DETROIT DIESEL

DDEC® VI Troubleshooting

NUMBER: 07 DDEC VI-40 S.M. REF.: 90 ENGINE: EPA07 MBE 4000 DATE: December 2007

SUBJECT: 2630/FMI 3 AND SPN 2630/FMI 4

Figure 1 Intake Manifold Pressure/Temperature Sensor

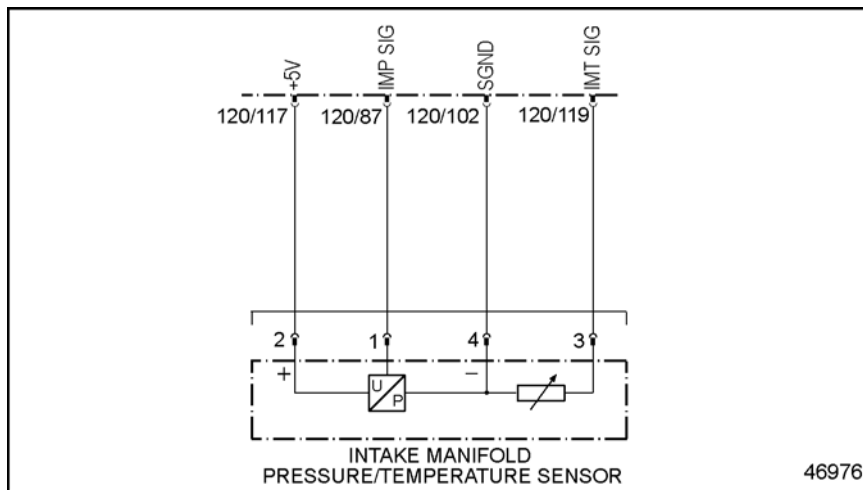
3. Measure the voltage between pins 3 and 4 of the Intake Manifold Pressure/Temperature Sensor harness connector.
 - [a] If the voltage is between 2.75 and 3 volts replace the Intake Manifold Pressure/Temperature Sensor.
 - [b] If the voltage is less than 2.75 volts, go to step 4.
4. Measure the voltage between pin 3 of the Intake Manifold Pressure/Temperature Sensor harness connector and ground.

- [a] If the voltage is between 2.75 and 3 volts repair open between pin 4 of the Intake Manifold Pressure/Temperature Sensor harness connector and pin 102 of the MCM 120-pin connector.
- [b] If the voltage is less than 2.75 volts, repair open between pin 3 of the Intake Manifold Pressure/Temperature Sensor harness connector and pin 119 of the MCM 120-pin connector.

Figure 2 Intake Manifold Pressure/Temperature Sensor

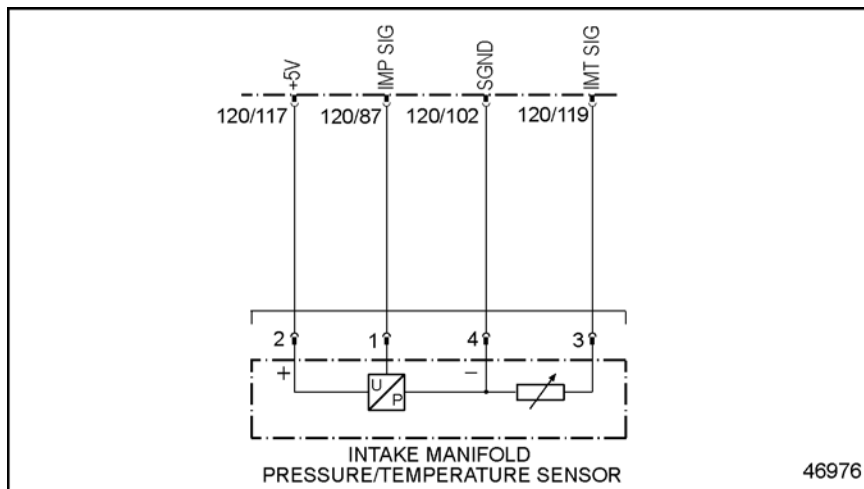
3. Measure the resistance between pin 3 of the Intake Manifold Pressure/Temperature Sensor and ground.
 - [a] If the resistance is less than 3 Ω , repair short to ground between pin 3 of the Intake Manifold Pressure/Temperature Sensor and pin 119 of the MCM 120-pin connector.
 - [b] If the resistance is greater than 3 Ω , replace the Intake Manifold Pressure/Temperature Sensor.
